PURCHASE ORDER CHANGE REQUEST

**Agency:** Natural Resources/Oil, Gas & Mining  
**Contact Person and Title:** Priscilla Burton, Project Manager  
**E-mail address:** [priscillaburton@utah.gov](mailto:priscillaburton@utah.gov)  
**Phone number:** 435-613-3733  
**Date:** August 2, 2011  
**Solicitation No.** AR11035  
**Purchase Order No.** 560 12000000007  
**Change Order No.** 4

**TITLE**  
R645-301-527  
WHITE OAK LOADOUT FACILITY  
RECLAMATION

Drawn by: JEFF JENSEN Date: 8/1/03  
Approved: \_\_\_\_\_ Date: \_\_\_\_\_  
Drawing No: R645-301-527 Rev: 1

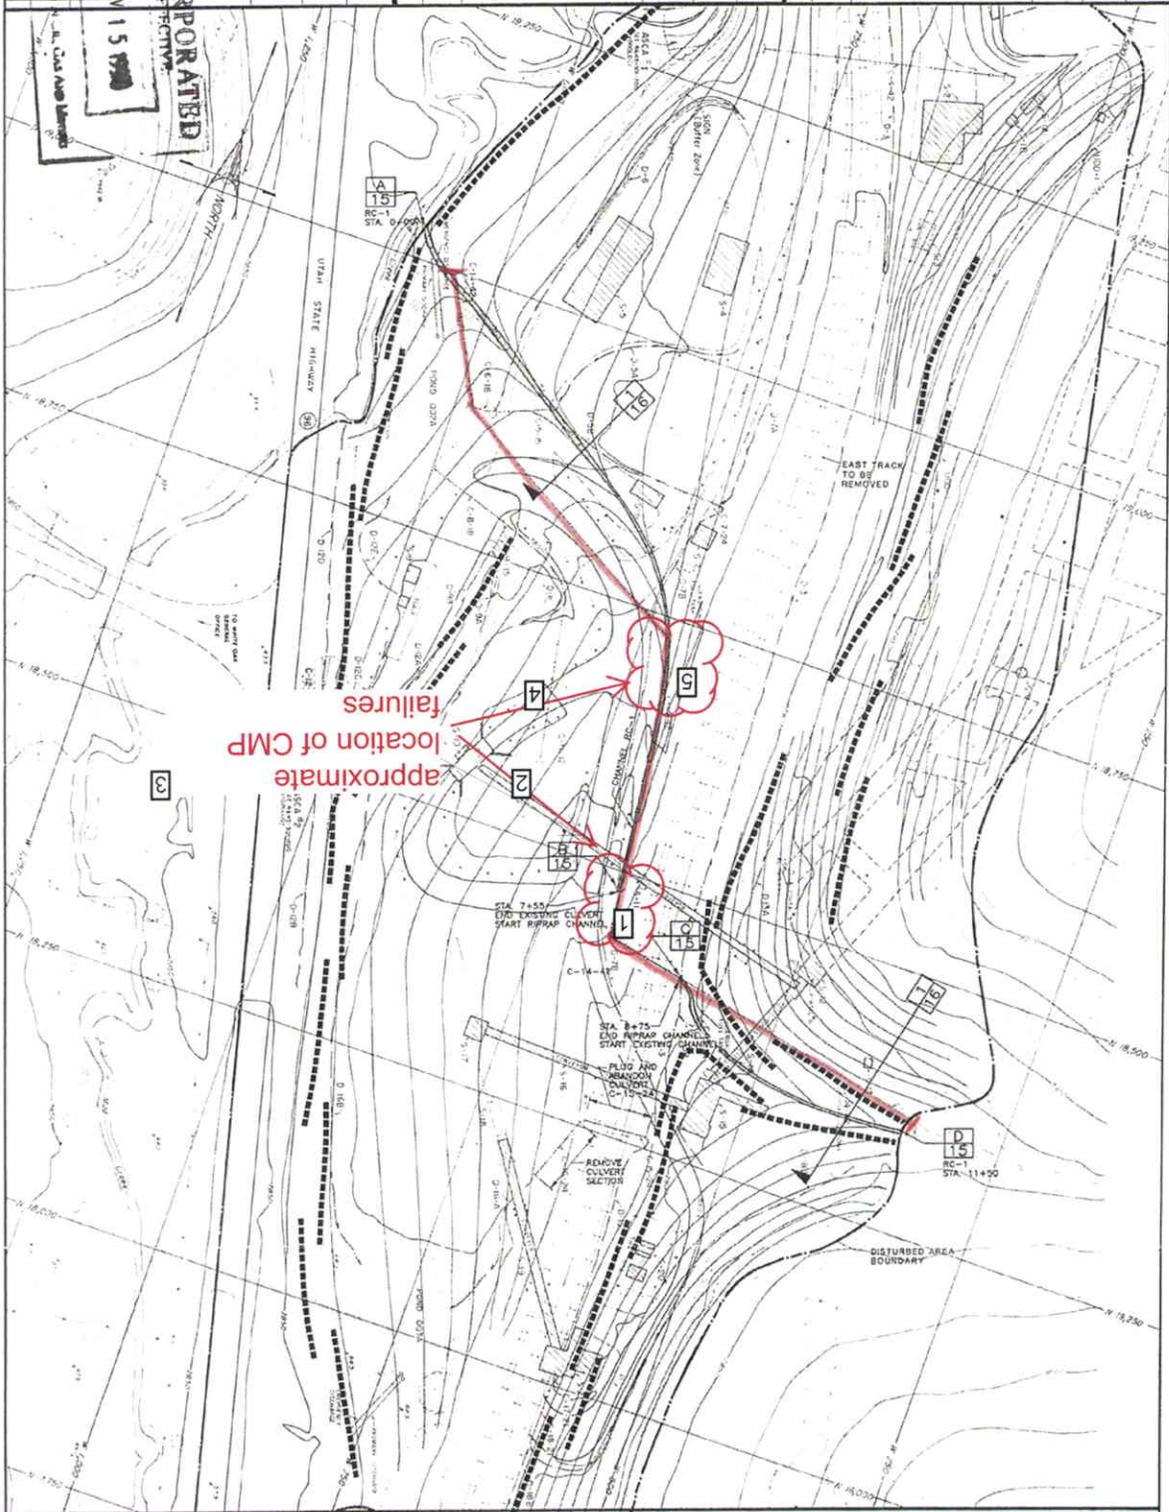
The existing 42" CMP Culvert located at the White Oak Loadout Site has been crushed in two locations. The culvert is filled with debris and the capacity to carry water has been severely impaired.

failures  
location of CMP  
approximate

Item	Quantity	Unit	Description	Unit Price	Amount
1	1	LS	Mobilization of Equipment and Materials	\$965.00	\$965.00
2	40	LF	42" CMP	\$45.55	\$1,822.00
3	40	LF	Excavation, installation and backfill of 42" CMP	\$54.25	\$2,170.00
<b>Grand Total</b>					<b>\$4,957.00</b>
